Crab Plan Team Report

The Crab Plan Team convened their May meeting from May 22-24, 2007 at the Alaska Fisheries Science Center in Seattle, WA.

Review of Crab Overfishing Definitions analysis (Proposed amendment 24)

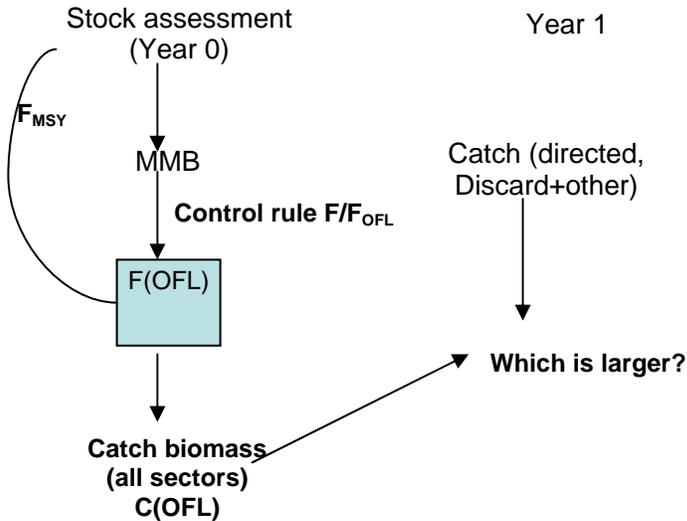
André presented a figure characterizing the process of analysis and application of the overfishing determination. A figure along the lines of that below should be included in the revised Chapter 2 to help clarify the simulation process and how (and when) this process interfaces with the stock status determination as well as at what stage (analytically) we move from MMB to total catch. This figure would need to be further modified to include the process of status determination for “overfished” status ($1/2 B_{MSY}$) as well in Year 0.
